The Scheme was discussed in the 421<sup>st</sup> Screening Committee Meeting held on 07.03.2024 vide item no 10:2024. The proposal was presented by SA (Sports). After detailed deliberations the proposal was Approved with the following observations:

PROJECT TITLE :-  
**PROPOSED MULTI PURPOSE HALL, TERRACE SEATING & SWIMMING POOL IN EXISTING GOLF FACILITY CENTRE BUILDING - QUTUB GOLF COURSE AT LADO SARAI**

DRG. TITLE	DRG. ISSUED FOR	NORTH
LAYOUT PLAN	SCM DRAWING	
SCALE : NTS	DATE : 20-06-2024	DRG. NO. : DDA/US/SCM/QG02/1
ARCH. ASSTT	ASSTT. DIR. (ARCH)	DEPUTY DIRECTOR (ARCH)
SR. ARCHITECT	ADDL. CH. ARCHITECT	CH. ARCHITECT

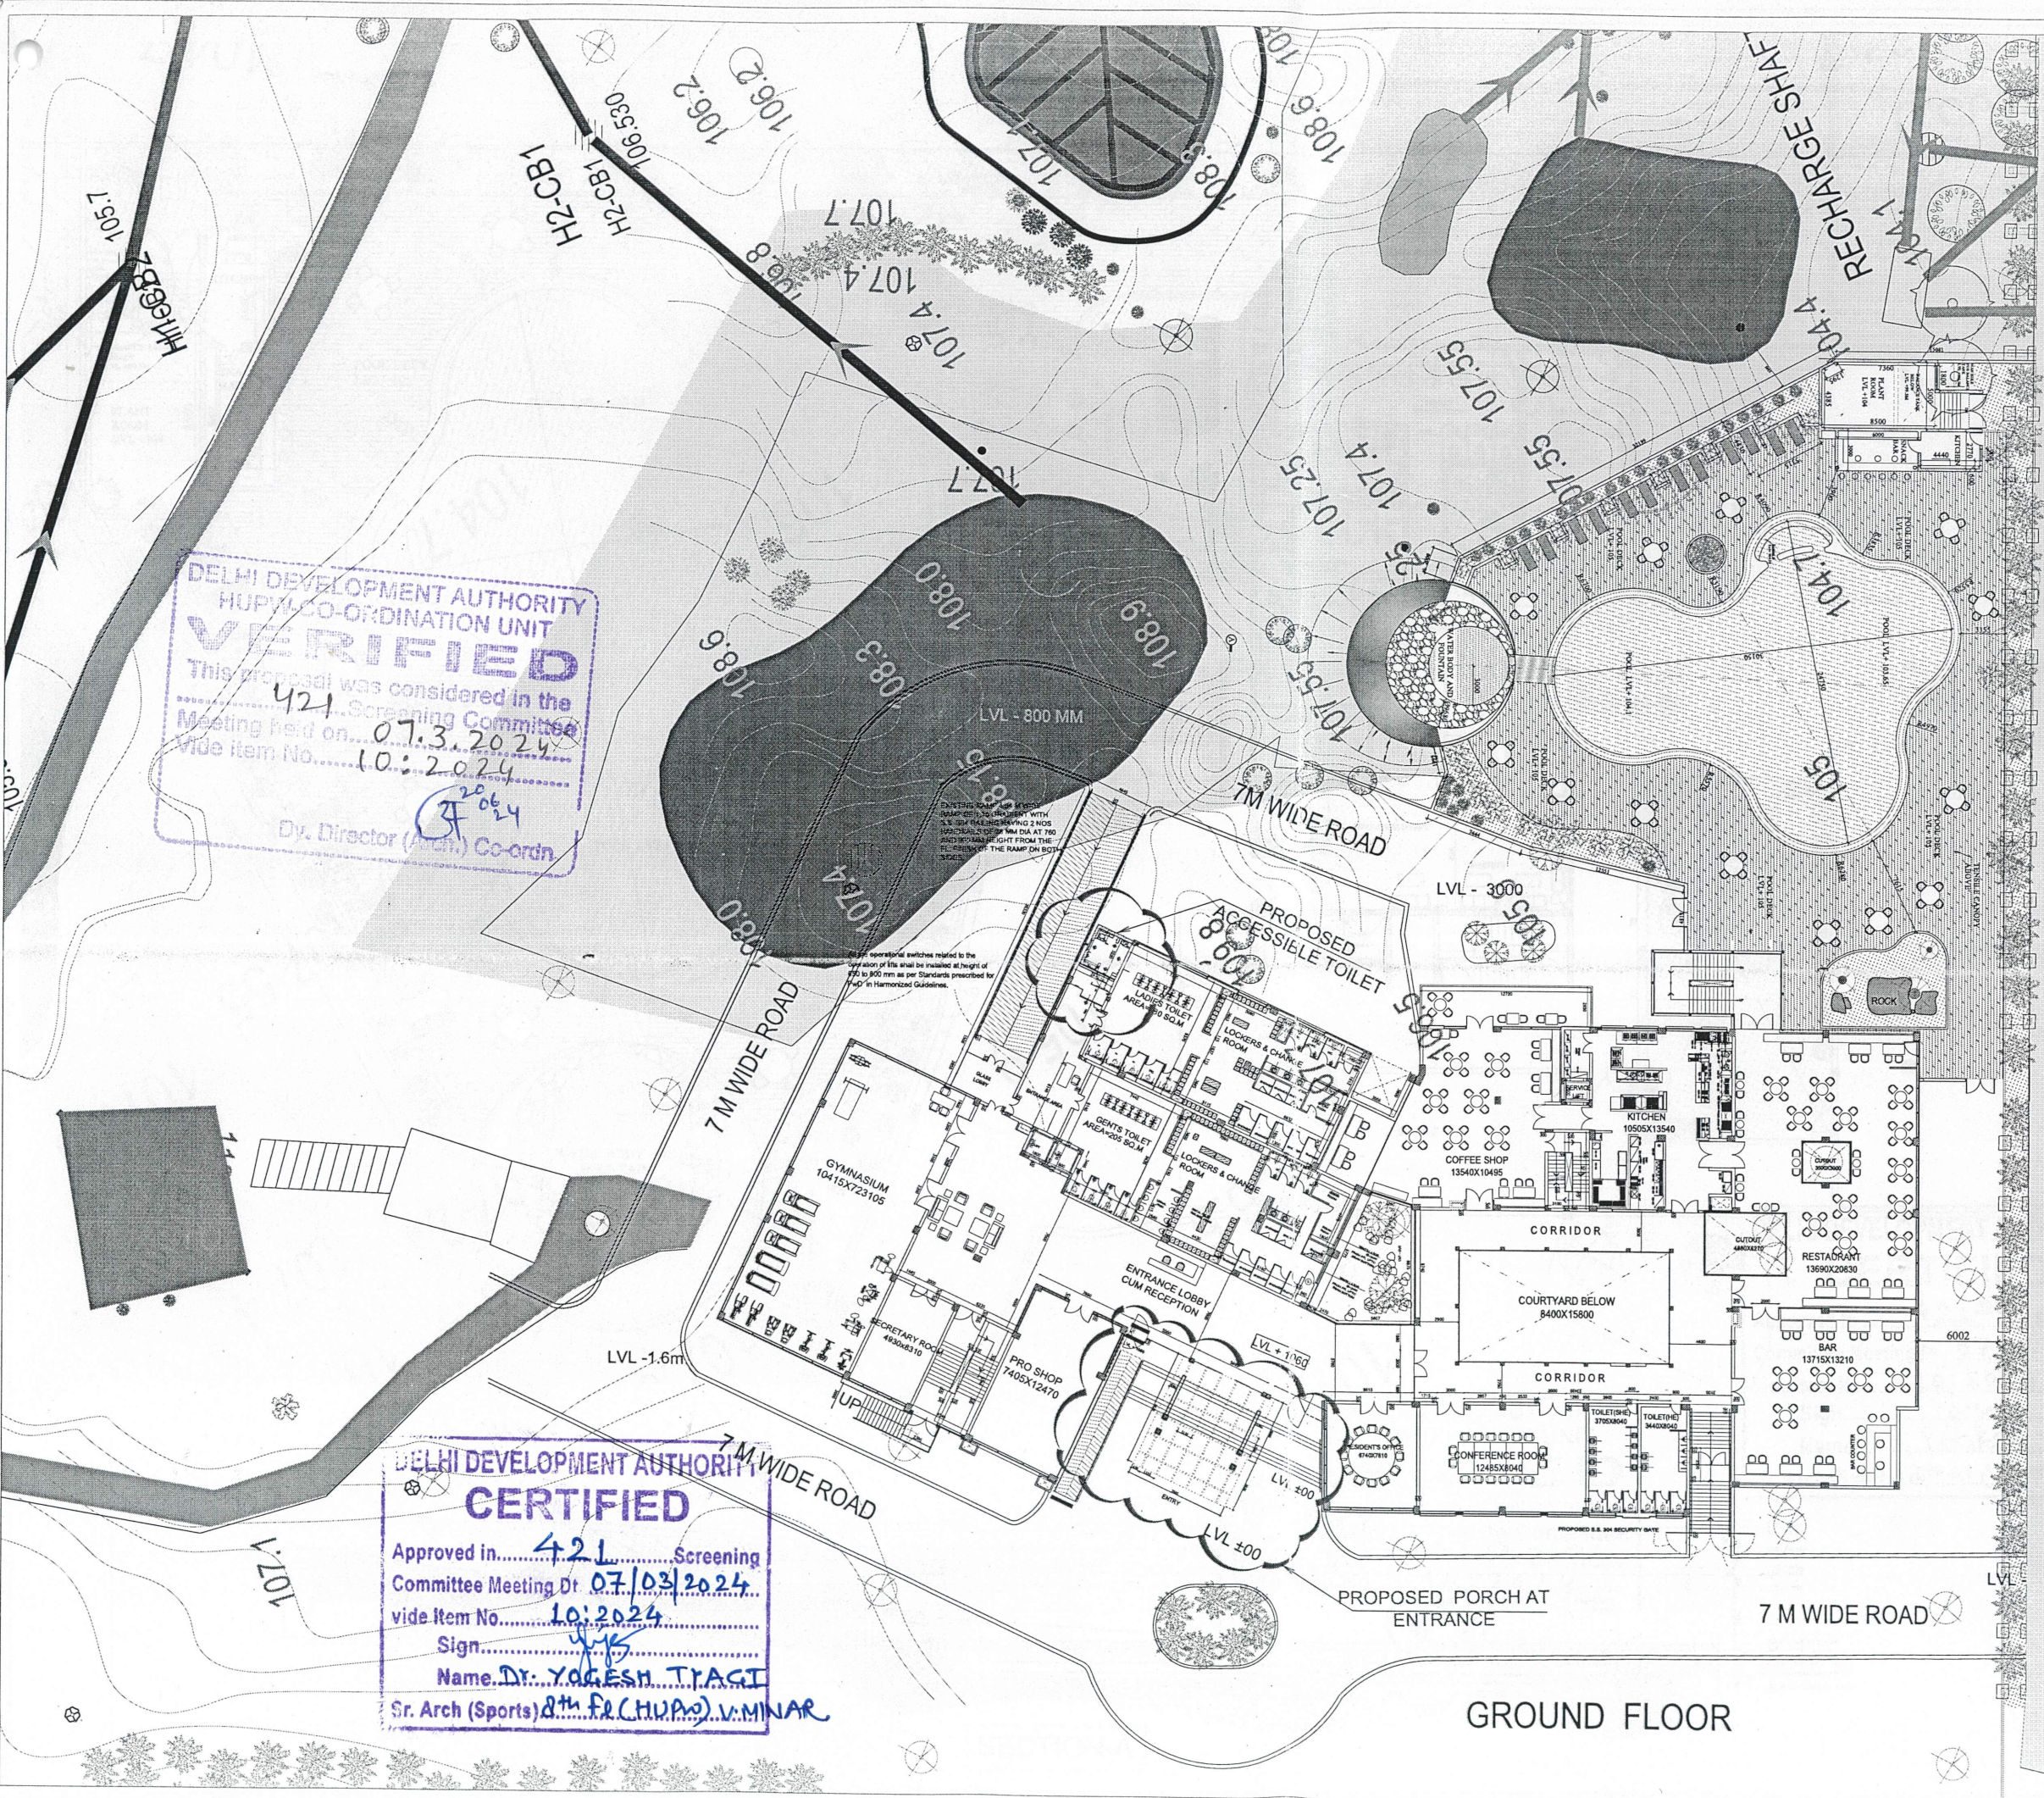
- i. The visual connectivity from the terrace level to the surrounding golf greens to be ensured by way of design.
- ii. RCC slab over lobby be replaced with a light structure (such as pergolas) keeping in view the concept of openness.
- iii. Financial feasibility w.r.t. O&M of swimming pool and fitness center (by incorporating Spa, Sauna etc.) may be looked into.
- iv. The scheme of covering over entrance porch to be decided after site visit.

As per the observations of 421<sup>st</sup> Screening Committee Meeting, all the changes suggested by Screening Committee have now been incorporated in the revised drawings.

- i. The visual connectivity from the terrace level to the surrounding golf greens have been ensured through transparent MS pergola/ frame with open terrace seating for dining with provision of two guest rooms as discussed during site visit.
- ii. RCC slab over lobby have been replaced with a light structure of pergola.

- iii. Spa, Sauna etc. facilities have been incorporated with swimming pool in stilt area.
- iv. The scheme of covering over entrance area been decided and incorporated in drawings after site visit.

Due to incorporation of above observations in scheme, minor changes in the area and number of drawings occurred in the revised drawings, which have been revised accordingly.
